Reliability Analysis Update PJM West

Bo Zhang
Sub Regional RTEP Committee – PJM West

September 18, 2026

Baseline Reliability Projects Changes to Previously Approved Projects

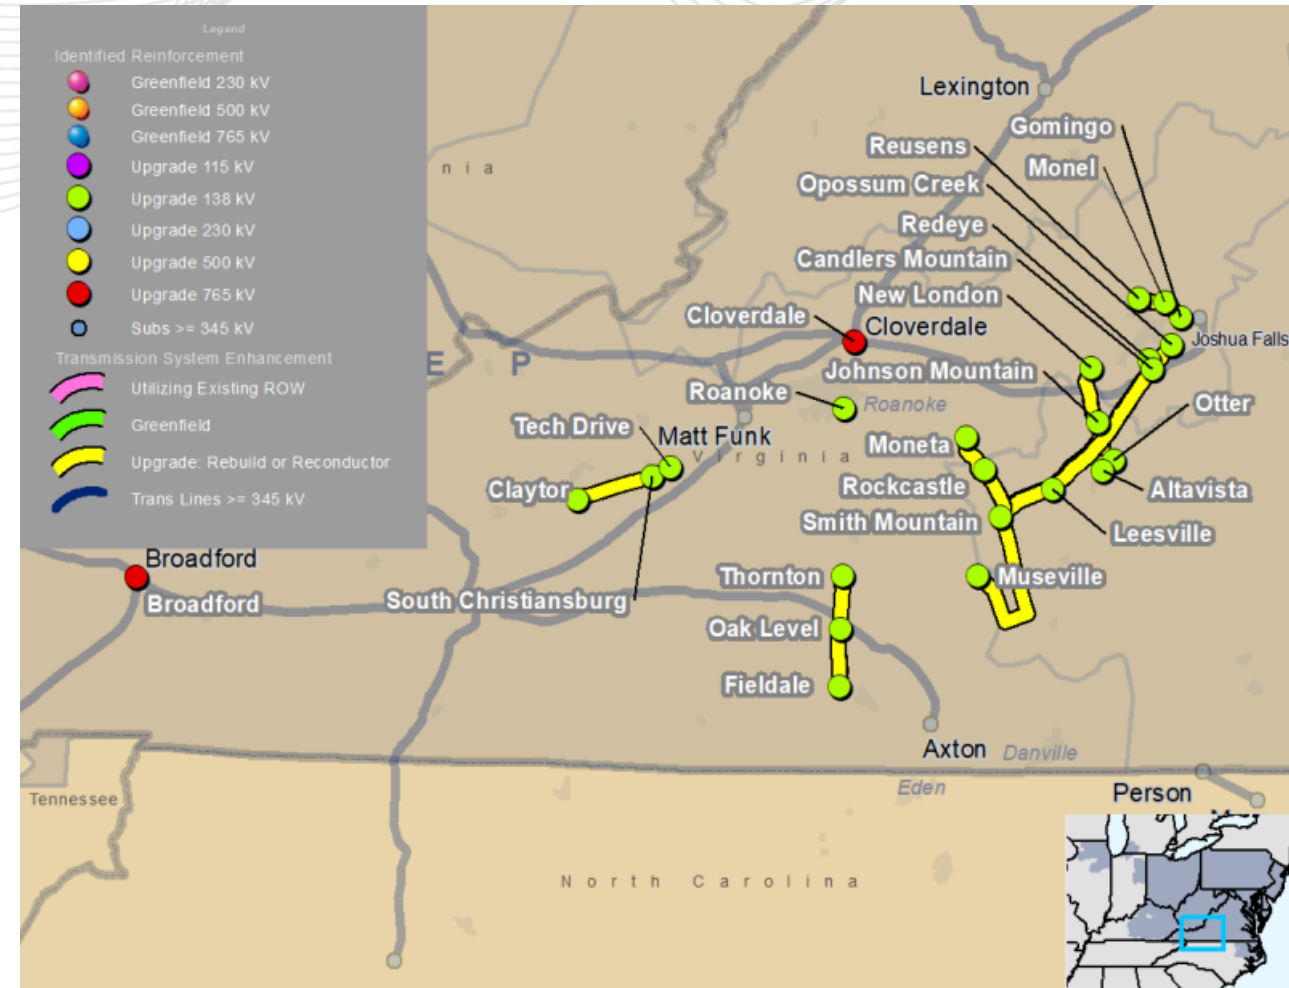
B4000.201 was presented on 1/7/2025

Project Scope Update(marked in red): Smith Mountain 138 kV Upgrade: Replace 795 KCM AAC, 37-Str. 795 KCM AAC, 37-Str. PH A B2S1 B2S2 BS1 BS2; **Replace 138 kV disconnect switches associated with breakers C and C2. (B4000.201)**

Estimated Cost: ~~\$0.4 M~~ **1.4 M.**

Reason for Scope Change: PJM loading requirements and target ratings were reviewed between AEP and PJM to ensure the ultimate scope of work would accommodate the anticipated loadings with an appropriate operating margin. As a result of that review, additional work was identified as mentioned above in red. This additional station scope contributed to the increase from the original \$0.4M cost estimate to the current \$1.4M.
